June 26, 2008

***Addendum to Revised Holifield Park Supplemental Investigation and Groundwater Remediation Work Plan, Defense Fuel Support Point Norwalk, 15306 Norwalk Boulevard, Norwalk, California (SCP No. 0286A, Site No. 16638)***

**ATTACHMENT 1**  
**PROPOSED EXPANDED GROUNDWATER REMEDIATION SYSTEM**

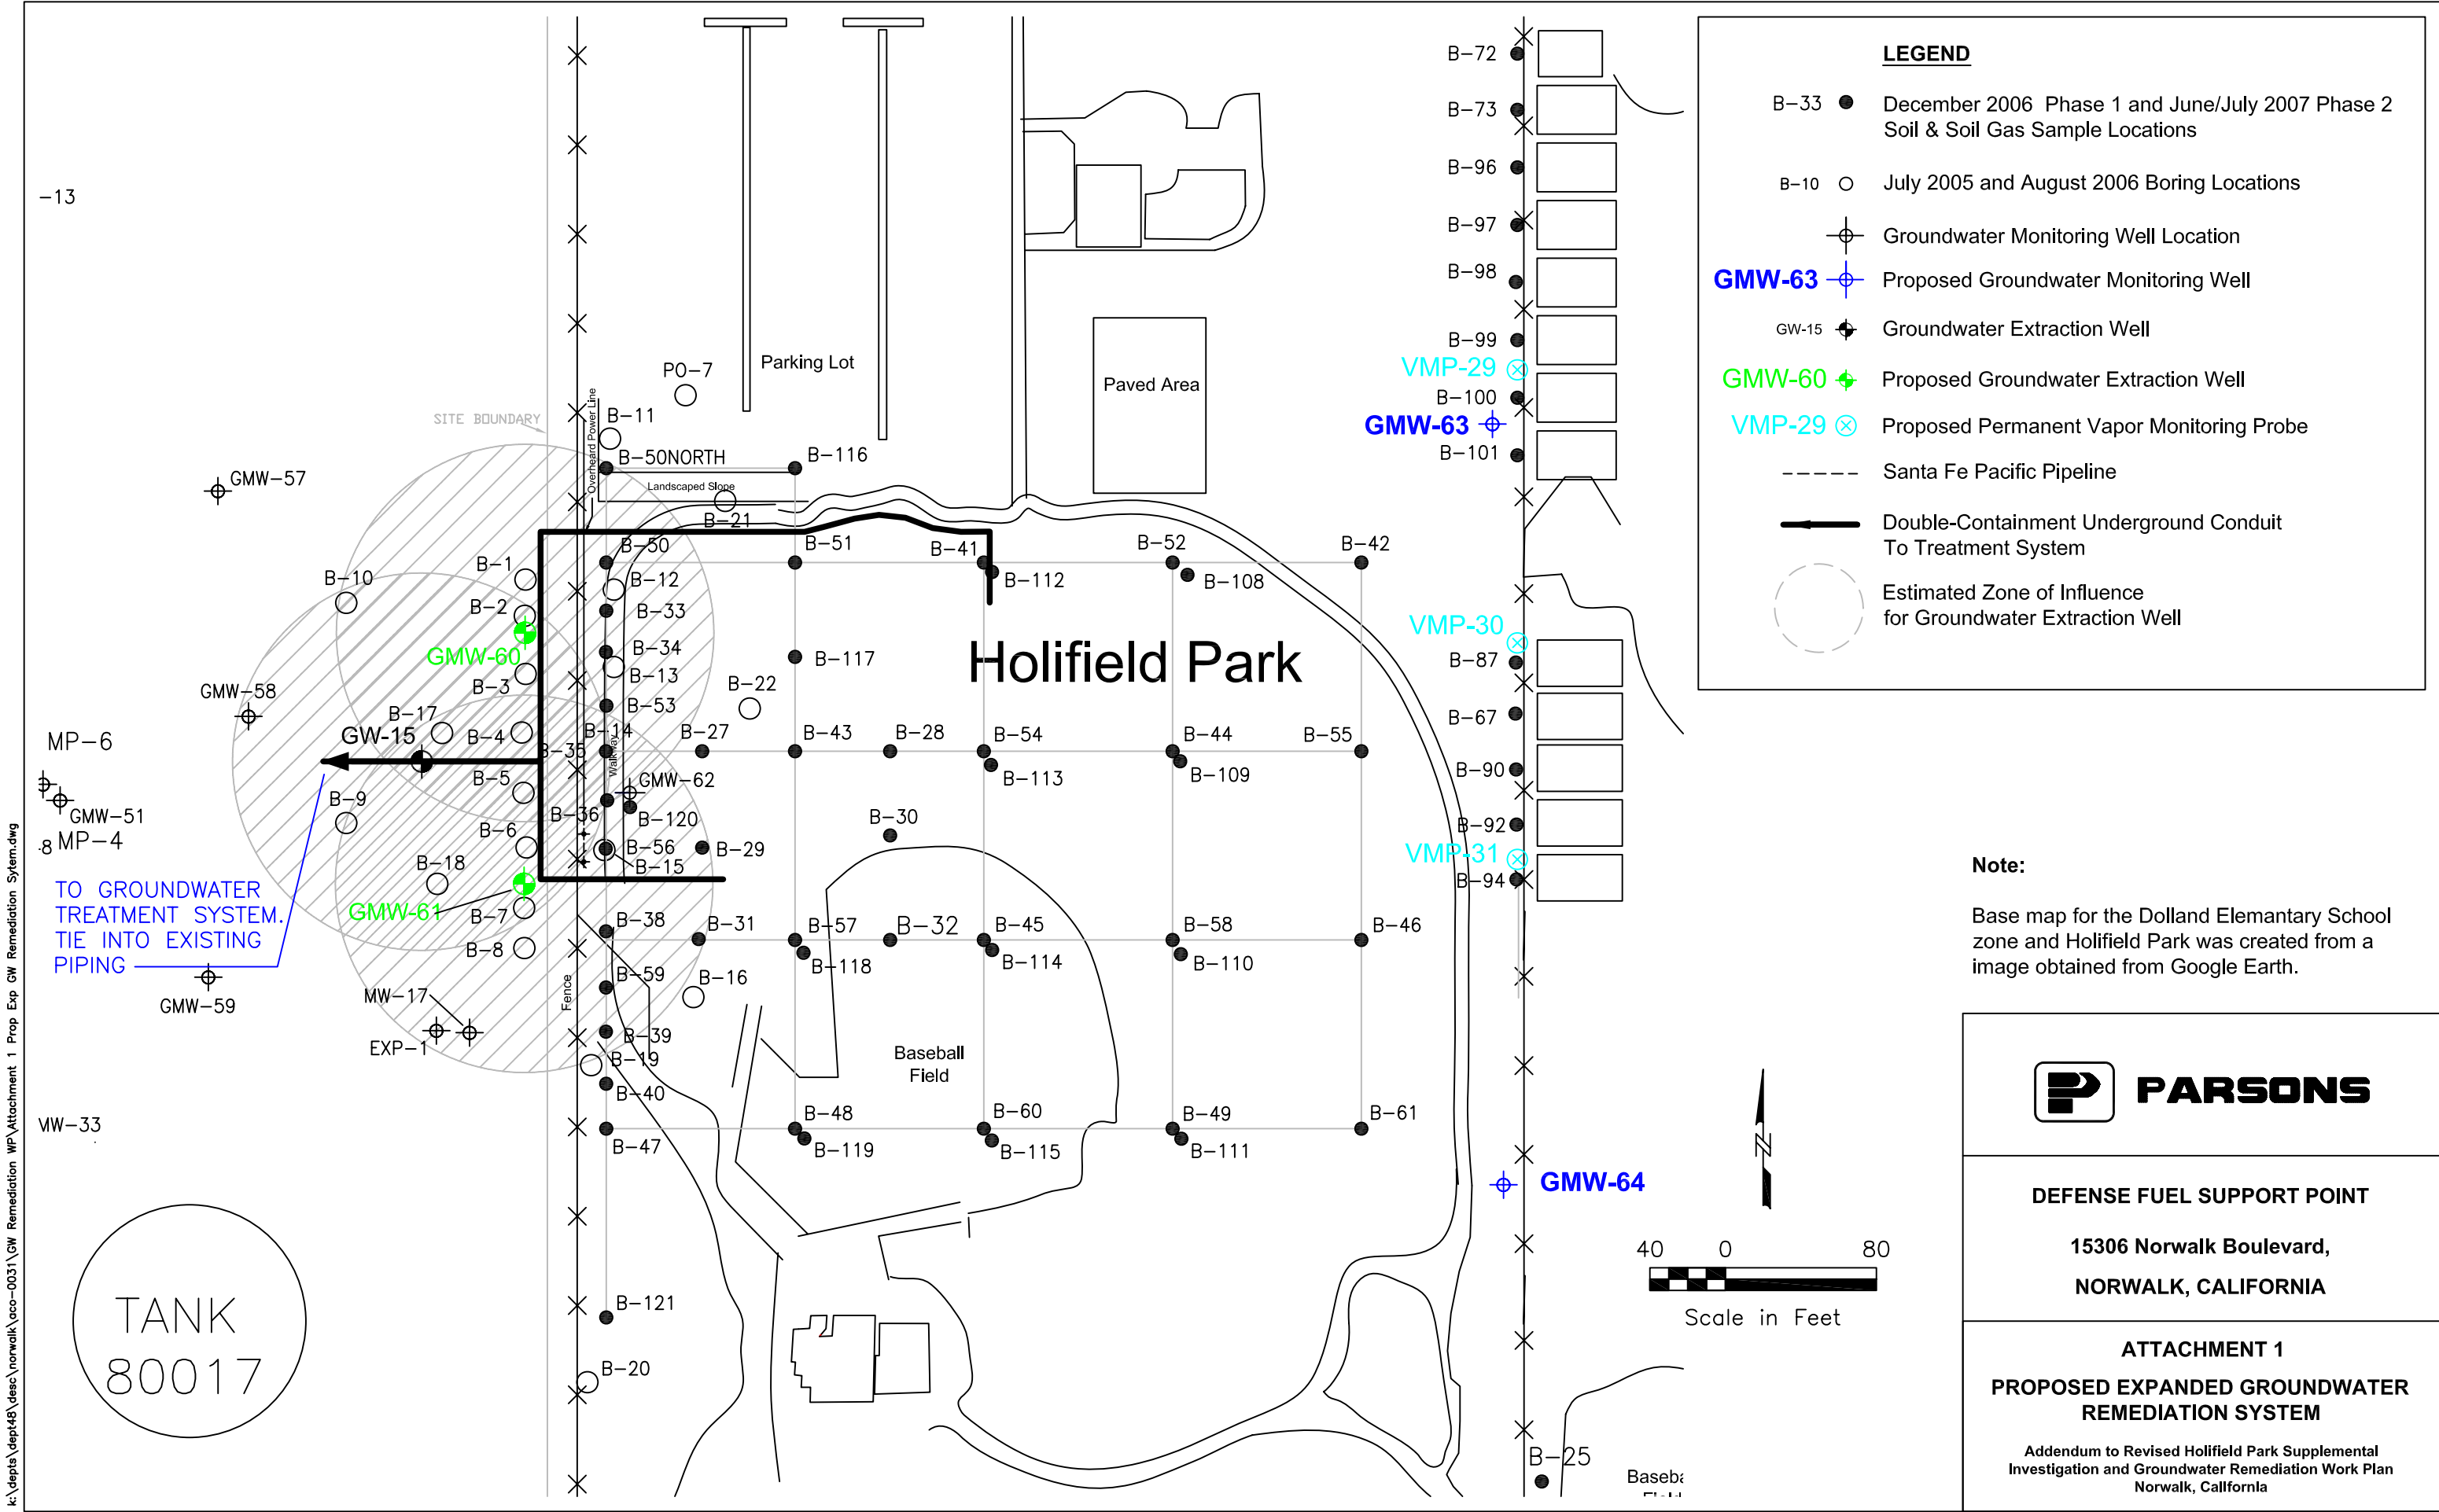
- Proposed Change: Parsons recommends that the proposed groundwater extraction wells (GW-16 and GW-17) not be installed in the park. After further strategic planning and data review, it was concluded that installing and operating these new

wells from the park would carry the potential of drawing the on-site plume further into the park, and therefore further damaging groundwater quality. Selection of new groundwater wells will have to take into account full containment of on-site plume(s) within the site boundaries, and if practically feasible pull any potential off-site impact back towards the site.

- Proposed Alternate Scope of Work: If needed, additional groundwater extraction wells within the site boundaries along the fence adjacent to the park will be installed. Initially, existing monitoring wells, GMW-60 and GMW-61, will be retrofitted for groundwater extraction and piped to the treatment system (Attachment 1). These locations will fulfill the requirements stated above and will provide an appropriate hydraulic barrier, which will consequently have the potential of containing and “recovering” the plume on-site. The wells will be equipped with extraction pumps, wired electrically for automated and manual controls, piped to the groundwater treatment system, and programmed into the PLC. Once extraction begins from these two wells, these wells in addition to existing extraction well GW-15 will be operated on a continuous basis. After three months of continuous operation, groundwater chemistry will be evaluated from existing onsite wells and GMW-62 located in the park (and at any new wells installed in the park). Groundwater quality will be compared to historical to determine effectiveness of groundwater extraction in this area and to determine if additional onsite extraction wells are required in order to contain the plume within site boundaries. Additional extraction wells will be installed within the site if needed.
